Proposed Resource Consent Applications before the Whangarei District Council and Northland Regional Council – s92(1) Request for additional Information

Applicant: Meridian Energy Limited
Location: Sites 1 – 3, State Highway 15A, McCathie, Marsden Point and Rama Roads, Ruakaka
Reference: Whangarei District Council LU2300093
Northland Regional Council APP.045356.01.01

In the matter of: Meridian Energy Limited (MEL) Proposed solar energy farm development at Ruakaka.

Figure 1: (BML) Figure 12: NPS Natural Inland Wetlands and watercourses in Site 1 of the Ruakākā Energy Park

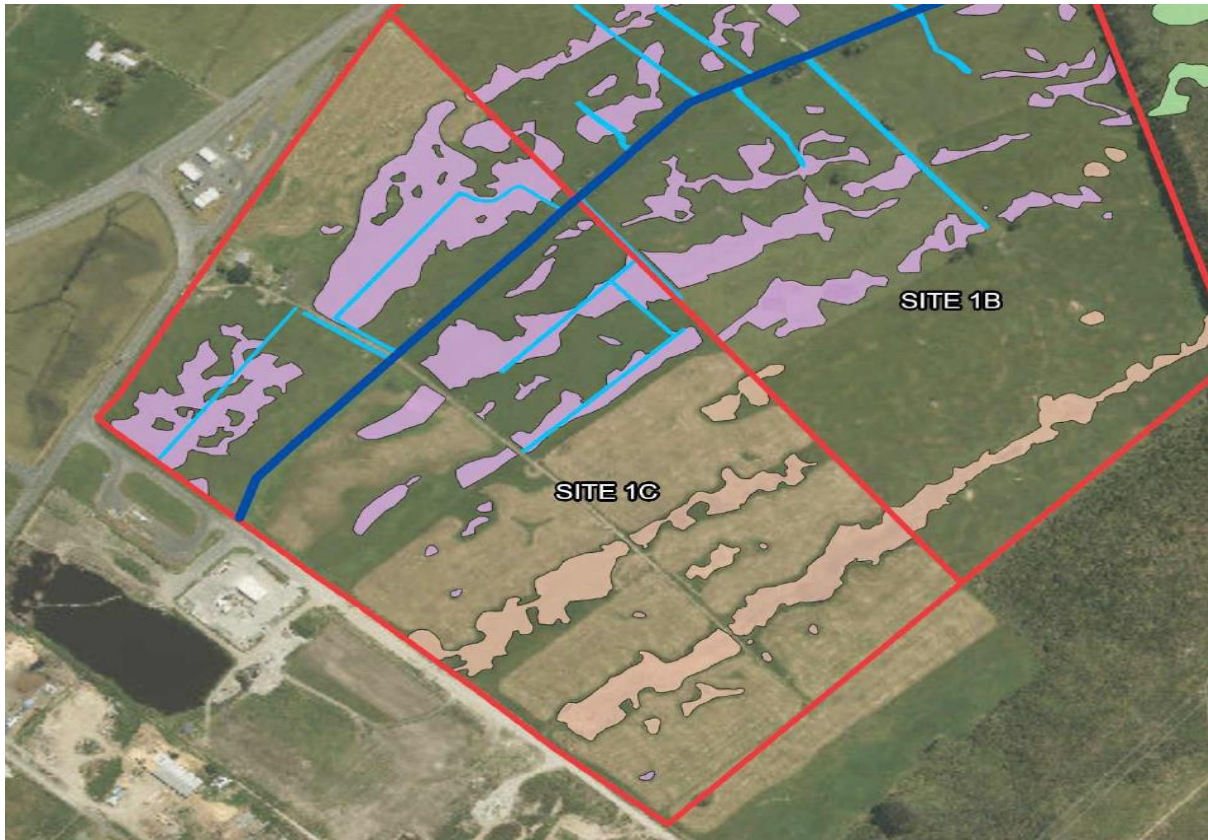
4. Based on the brief site visit undertaken on the 28th of September 2023 there appears to be rather large discrepancy between the BML mapped wetland extent (Figure 1) and what can be observed on the ground. A small example of the BML mapped wetland areas compared with the potential additional wetland extent based on the most recent Google aerial imagery is provided below (Figure 2). It appears that the discrepancy in the overall natural inland wetland extent on site compared between BML mapping and a rapid desktop analysis carried out by RDL based on the most recent aerial imagery, is quite significant. It is noted that the BML assessment has relied on the 'rapid test' applied at locations across the project site, that BML have based their overall mapping exercise on a representative selection of identified wetland features being GPS'd through Fieldmaps, and that not all wetland areas on site had been ground-truthed/delineated. This is not deemed appropriate given that the proposal is based on "removal" of nearly 90% of the wetland areas on Site 1, so appropriate delineation of all wetland areas on site based on delineation carried out on the ground is required. Based on these results alone and without up-to-date aerial imagery overlaid, there is no context to the results of the wetland delineation carried out by BML. Please provide updated mapping and calculations to reflect the current wetland extent on Site 1 using accepted wetland delineation methods (MfE Wetland delineation protocols 2022) ensuring that all wetland areas have been appropriately delineated/ground-truthed.
